Contract #: 04-0120F4Cty: SF/ALA Rte: 80 PM: 13.2/13.9File #: 69.25B**QUALITY ASSURANCE -- NON-CONFORMANCE REPORT****Location:** Changxing Island, Shanghai, PRC**Report No:** NCR-000350**Prime Contractor:** American Bridge/Fluor Enterprises, a JV**Date:** 14-Jul-2009**Submitting Contractor:** Zhenhua Port Machinery Company, Ltd (ZPMC), Changxing Island**NCR #:** ZPMC-0324**Type of problem:****Welding****Concrete****Other****Welding****Curing****Procedural****Bridge No:** 34-0006**Joint fit-up****Coating****Other****Component:** OBG Segments 6AW, 7BW, 7DE, and 7DW**Procedural****Procedural****Description:****Reference Description:** Cope Holes not to Specification**Description of Non-Conformance:**

Job Name: SAS Superstructure
Document No: 05.03.06-000332

Reference Description: Cope Holes not to Specification

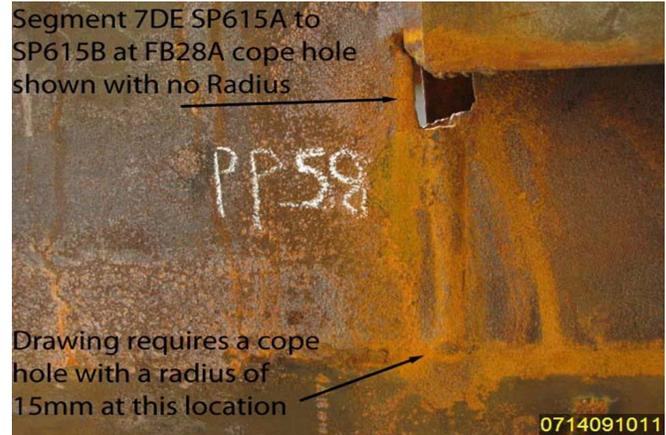
During in-process visual inspection of Segments 6AW, 7BW, 7DE, and 7DW Caltrans Quality Assurance Inspector observed cope hole sizes and locations do not comply with the approved shop drawings. Cope holes are located at the side panel (SP) complete joint penetration (CJP) butt welds and the bottom plates where the FL3 type floor beam (FB) penetrates through the side plates. Additionally, cope holes do not exhibit a smooth transition free from notches. Listed below are the locations of the cope holes.

Segment	Panel Point	SP to SP	Floor Beam	Required Cope Hole Size	Remarks
6AW	38	SP751A-SP751B	FB19A	R=25mm	Needs to be ground smooth
6AW	38	SP751A-SP751B	FB19A	R=25mm	Needs to be ground smooth
6AW	38	SP751A-SP751B	FB19A	R=15mm	Hole is missing
6AW	39	SP751B-SP752A	FB29A	R=25mm	Needs to be ground smooth
6AW	39	SP751B-SP752A	FB29A	R=15mm	Hole is missing
6AW	40	SP752A-SP752B	FB33A	R=25mm	Needs to be ground smooth
6AW	40	SP752A-SP752B	FB33A	R=15mm	Hole is missing
7BW	50	SP757A-SP757B	FB39A	R=25mm	Needs to be ground smooth
7BW	50	SP757A-SP757B	FB39A	R=15mm	Hole is missing
7BW	51	SP757B-SP758A	FB23A	R=25mm	Needs to be ground smooth
7BW	51	SP757B-SP758A	FB23A	R=15mm	Hole is missing
7BW	52	SP758A-SP758B	FB27B	R=25mm	Needs to be ground smooth
7BW	52	SP758A-SP758B	FB27B	R=15mm	Hole is missing
7DE	56	SP614A-SP614B	FB20B	R=25mm	Needs to be ground smooth
7DE	56	SP614A-SP614B	FB20B	R=15mm	Hole is missing
7DE	57	SP614B-SP615A	FB24A	R=25mm	Needs to be ground smooth

7DE	57	SP614B-SP615A	FB24A	R=15mm	Hole is missing
7DE	58	SP615A-SP615B	FB28A	R=25mm	Needs to be ground smooth
7DE	58	SP615A-SP615B	FB28A	R=15mm	Hole is missing

Install and modify cope holes to conform to shop drawings.
